**APPENDIX C8**  
**COMMENTS AND RESPONSES REPORT**

## KLEINZEE SOLAR PHOTOVOLTAIC FACILITY, NORTHERN CAPE PROVINCE

(DFFE Ref. No.: 14/12/16/3/3/1/2764)

### COMMENTS AND RESPONSES REPORT

**Figure 2** Critical Biodiversity Areas in the vicinity of the proposed Daisy and Kleinzee PV facilities

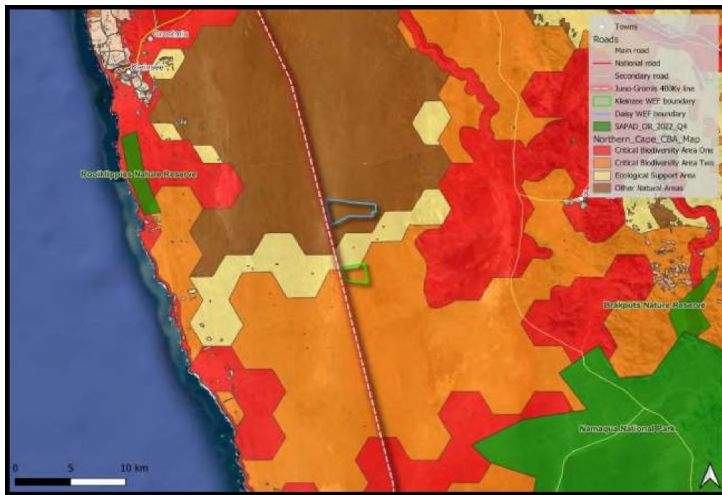
**Critical Biodiversity Areas:** The proposed Daisy PV facility is not located in a CBA area according to the 2016 Critical Biodiversity Areas map of the Northern Cape (Figure 2). The proposed Kleinzee PV facility is located mostly in a CBA 2 area. The reason behind the mapping of the CBA 2 is to protect this vegetation type and for water resource protection. In addition to the CBA, there is an ecological corridor situated between the two developments. It is unclear if this ecological corridor will be impacted (e.g., power lines, access roads).

The Terrestrial Ecology assessment assessed the location of the site considering the 2016 Critical Biodiversity Areas map of the Northern Cape. The terrestrial biodiversity specialist stated in the assessment report (**Appendix D**) that “areas of CBA2 are not considered to be irreplaceable; the development is not considered to have a very high impact on the affected CBA2, which is considerably larger than the site. In addition, the field assessment did not identify any significant biodiversity features within the site, with the result that the development would not have a high impact on biodiversity pattern features”.

The terrestrial biodiversity assessment indicated that the development would result in some impact on the CBA2 and the ESA corridor, which can be mitigated to a degree, and assessed residual impact on broad-scale ecological processes due to the presence and operation of the solar PV facility and associated infrastructure. Only associated infrastructure (including the access road and grid line) traverses the ESA corridor, and the impacts are limited to a corridor which is in line with the existing road and existing grid line in the area.

**Figure 5** Namaqua NP buffer zone and expansion footprint as extracted from the Draft Namaqua NP Management Plan (2024 - 2033). The proximate locations of the proposed Daisy and Kleinzee PV facilities has been superimposed on the images (red dots).

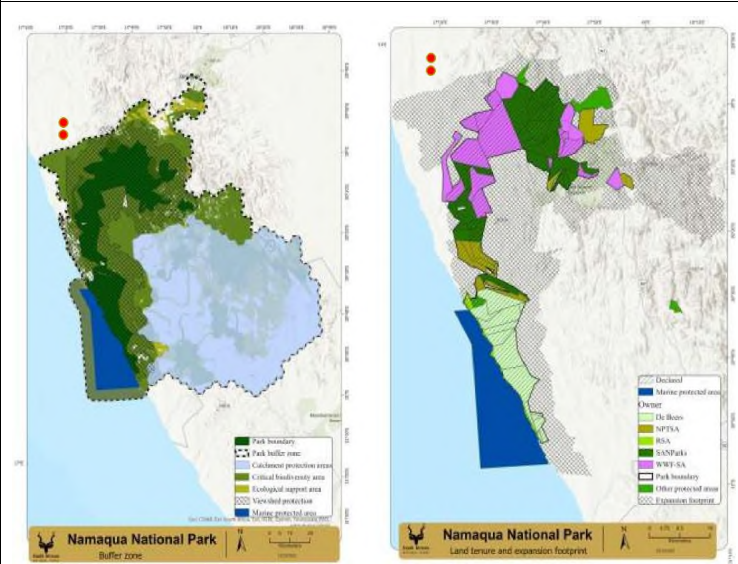
Draft Namaqua NP Management Plan (2024 – 2033), although the proposed development falls outside of the Park’s expansion footprint, buffer zone and viewshed protection (Figure 5). Kleinzee WEF is located approximately 18 km northwest of Namaqua NP and Daisy WEF 15 km east of Rooiklippies Nature Reserve. The Taaiboschvlak properties, as indicated in Figure 4, are earmarked for SANParks Biodiversity Offset Banking Pilot Project. Thus, these properties may also be included in the Namaqua National Park expansion plan as contained in the Draft Namaqua Management Plan (2024-2033).

PV facility will be located, and outside of the SANParks Biodiversity Banking Pilot Project as indicated in the Draft Namaqua National Park Management Plan (2024-2033).

The comment is noted and acknowledged.

As illustrated in the figure, the Kleinzee PV Solar facility falls outside the Namaqua National Park Buffer Zone, expansion footprint and viewshed protection, as extracted from the Draft Namaqua NP Management Plan (2024 - 2033).

**Figure 6:** (a) Renewable energy applications within 50km from the proposed Daisy and Kleinzee PV facilities and (b) extent of the Phase 1 Renewable Energy Development Zone

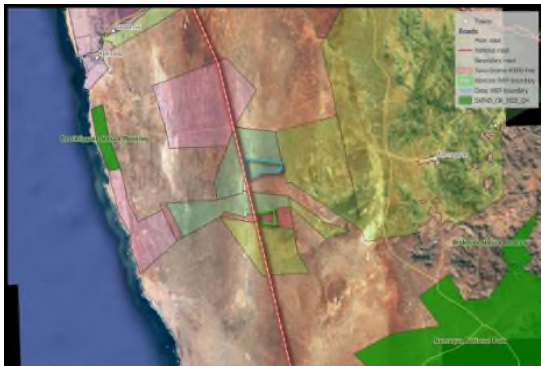
<p><b><u>Landscape connectivity, ecosystem fragmentation and cumulative impacts:</u></b></p> <p>Several renewable energy applications are located within the vicinity (50km) of the proposed Daisy and Kleinzee PV facilities (Figure 6). The concentration of renewable energy applications in the region is related to its occurrence within an expansive Renewable Energy Development Zone as well as the establishment of new ESKOM electricity grid infrastructure to which the facilities can connect. It is accepted that the proposed Kleinzee and Daisy PV Facilities are located in a gazetted Renewable Energy Development Zone, i.e. in an area that Government has determined to be generally suitable for WEF development. It nevertheless remains important to make every reasonable effort to minimise impacts on other land-uses within the REDZ. Following from the above DEARL is also highly aware of the complexity of attempting to reconcile different land-uses that may not be compatible. The same applies to situations where the overall benefit of a development might be strongly positive, but significantly negative consequences for small numbers of IAPs.</p>		<p>The comment is acknowledged. The developments fall within the Springbok REDZ and Northern Strategic Transmission Corridors. The gazetted Renewable Energy Development Zone is considered to be an area suitable for the development of both wind energy facilities as well as PV facilities. Compatibility of other land uses were assessed. The layout indicating the development footprint will be provided to DFFE for approval before any construction commences. The Kleinzee PV is located on the Namas Wind Farm development site and Daisy PV is located on the Zonnequa Wind Farm development site. These PV facilities are located on these properties in order to ensure nodal development, and minimise the area impacted by renewable energy projects.</p> <p>The cumulative map included in the BA report as <b>Figure 8.1</b> on page 216 considered the latest data (REEA quarter 4, 2022), from the Department of Forestry, Fisheries and the Environment Environmental Geographic Information Systems (E-GIS) webpage, as well as actual spatial data from projects with a valid EA. The validity of all project EAs was confirmed, and layouts considered as and where required.</p> <p>The development footprint for the Kleinzee PV facility is included in <b>Figure 9.1</b> in <b>Section 9.6</b> of the BAR. This map indicated the optimised facility layout based on all identified sensitivities.</p>

**Figure 8.1** of the BA report only the authorised renewable energy facilities are illustrated. **Chapter 8** of the BA report provides an assessment of the cumulative impacts, where significance ratings have considered the project/s in isolation, and with other projects with mitigation (refer to **Table 8.2** for a summary of the cumulative impact significance). It is noted that only those projects with a valid EA have been considered. No application for authorisation has been made for the Komass and Gromis wind farm projects, and as such are not considered in the cumulative assessment.

Namaqua NP buffer zone and expansion footprint as extracted from the Draft Namaqua NP Management Plan (2024 - 2033) are indicated below. The proximate locations of the proposed Daisy and Kleinzee PV facilities have been superimposed on the images (as red dots).

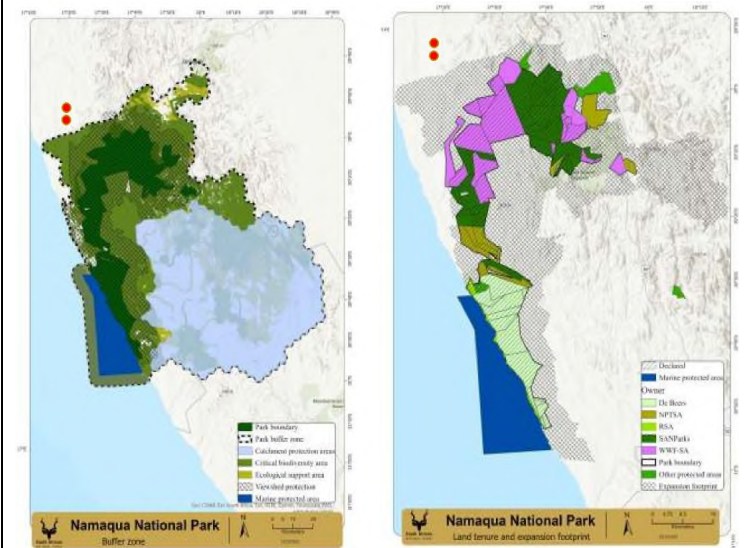
SANParks recognises the need for, and supports, renewable energy development in South Africa. SANParks acknowledges the competition for suitable WEF sites and the fact that the proposed developments lie within a renewable energy development zone. However, importantly, it is noted that the renewable energy zones were developed before the SANParks' Land Inclusion plan was adopted by the Minister of Forestry, Fisheries and the Environment (Minister). A portion of the proposed developments (see **Figure 1** below) falls within the expansion footprint of the Namaqua National Park. The proposed developments also fall within the current buffer zone of the Park.

By pursuing development within a recognised priority area for conservation (taking into account the multiple values of the affected area as a national protected area expansion strategy focus area, a CBA 2, the buffer zone of the Namaqua National Park and within the expansion footprint of that Park), the proposed

SANPark's support for renewable energy development is noted.

The Kleinzee Solar PV development falls within the current expansion footprint of the Namaqua National Park. However, in line with the Namaqua National Park draft Management Plan 2024 – 2033 the Kleinzee Solar PV facility is located outside the Park's buffer zone.
